Project	IEEE 802.16 Broadband Wireless Access Working Group < http://ieee802.org/16 >	
Title	RS Uplink HARQ on Dedicated Channel	
Date Submitted	2007-07-15	
Source(s)	Derek Yu, Hang Zhang, Peiying Zhu, Wen Tong, David Steer, Gamini Senarath, Mark Naden, G.Q. Wang Nortel 3500 Carling Avenue Ottawa, Ontario K2H 8E9	Voice: +1 613 763-1315 E-mail: [mailto:wentong@nortel.com] [mailto:pyzhu@nortel.com]
Re:	This document is in response to call for technical comments and contributions IEEE 802.16j-07/019 dated 2007-06-07.	
Abstract	The UL HARQ support defined in the current baseline is for centralized control. It involves substantial efforts to identify failure link and perform subsequent retransmission allocation. Whenever a failure occurs, all resources allocated beyond the failure link are wasted as well. As UL dedicated channel is a persistence allocation, there is no need for the MR-BS to reschedule retransmission. Hence, there is no needed to identify the failure link as well. This contribution proposes the required mechanism to enable HARQ control signaling and ACK/NACK exchange to support UL HARQ on the dedicated channel.

RS Uplink HARQ on Dedicated Channel

Figure XXX – UL DCH control header

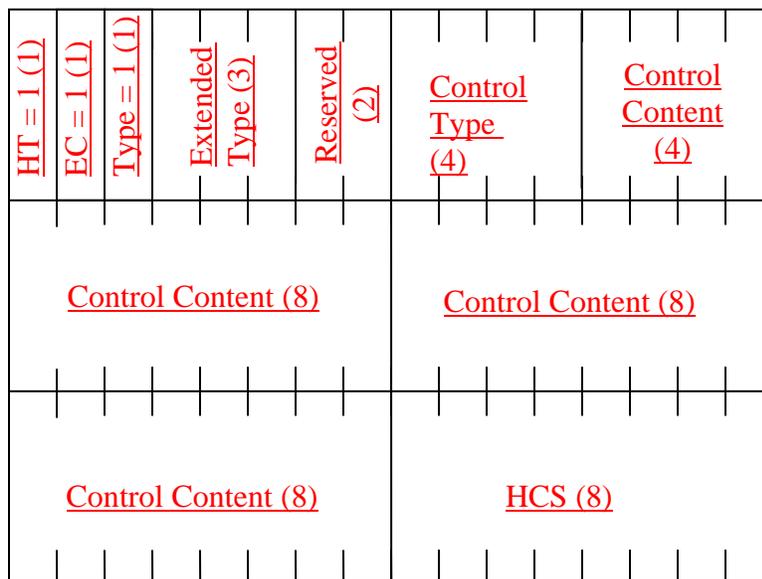
6.3.2.1.2.2.2.5 UL DCH control header

The UL DCH control header is used by the RS to send control signaling to MR-BS or parent RS. The header format is as follows:

Figure XXX. Format of DL MAC control header.

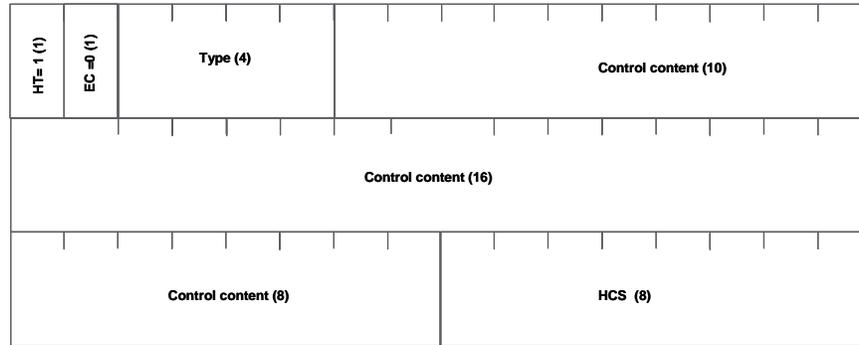
6.3.2.1.3 DL MAC Header without payload (DL MAC control header)

The DL MAC header without payload (control MAC header) is sent on DL only. The DL MAC control header is used by MR-BS or RS(s) to send control signaling to its child RS(s). The format of DL control MAC header is shown in Figure XXX.
